## FALSE WARNINGS THAT THE FRONT PASSENGER SEAT IS OCCUPIED WITHOUT THE SEAT BELT BUCKLED

This Service Information bulletin supersedes SI B72 04 17 **dated January 2019**

**PASSENGER OCCUPANCY DETECTION ERROR CORRECTION**

<b>UPDATE!</b>	
 <p>Position 1</p>	 <p><b>Do not attach the cable tie to any other seat parts. Just around the cable.</b></p>
<p>First cable tie position as shown in above photo</p>

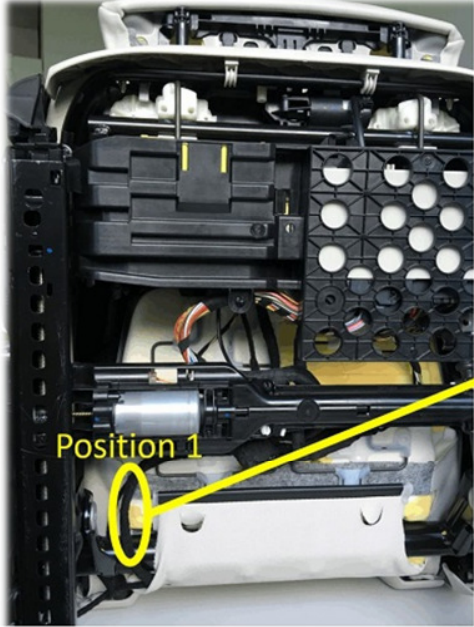
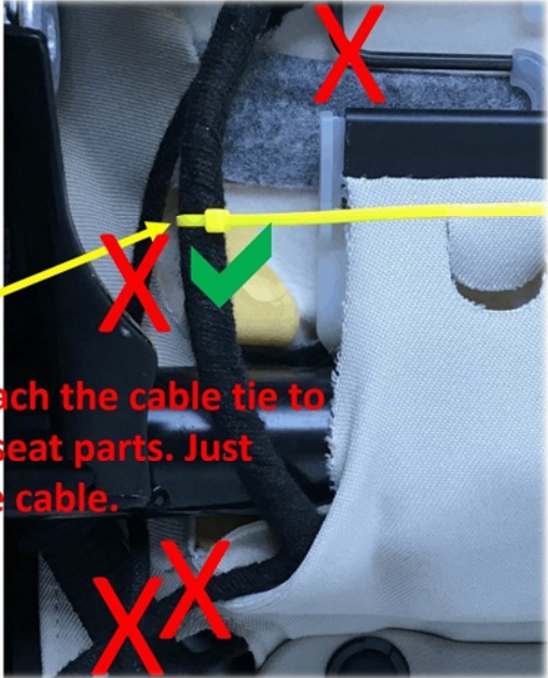
**UPDATE!** For cable tie position review the: <https://tinyurl.com/V520218>

Second cable tie position as shown in above photo

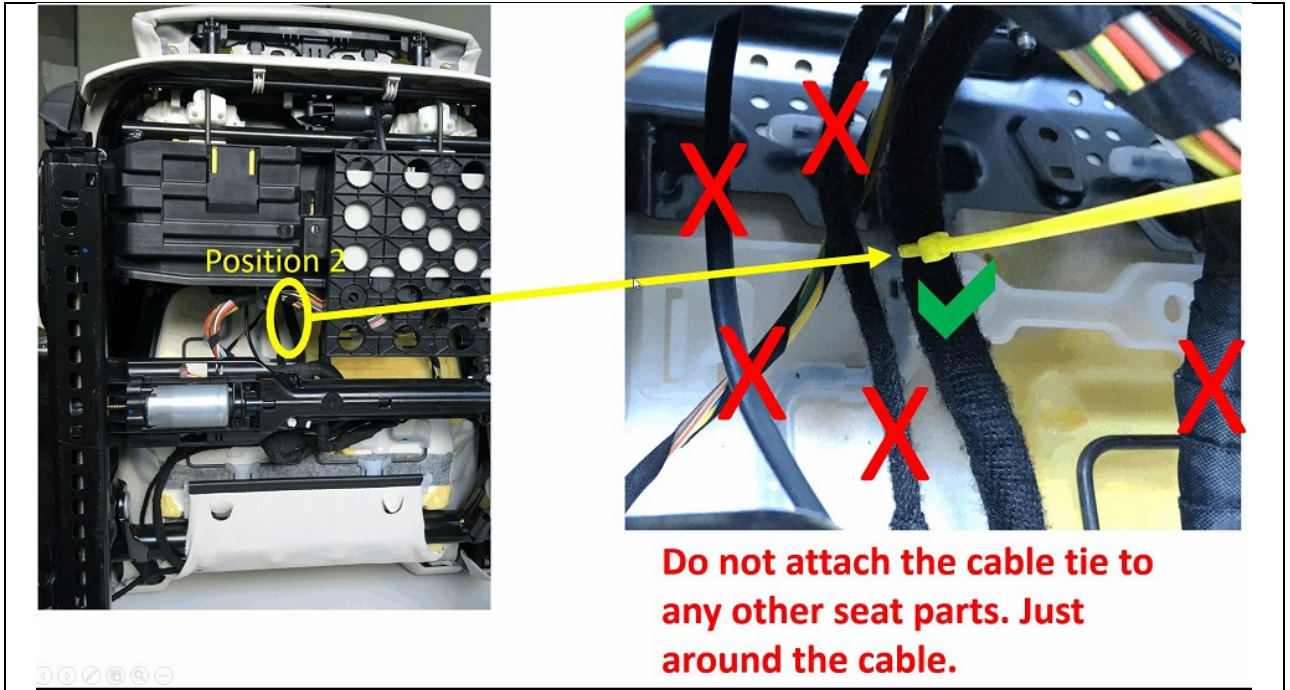
**UPDATE!**

9. With the tool showing in the picture tie the cable only around the harness.
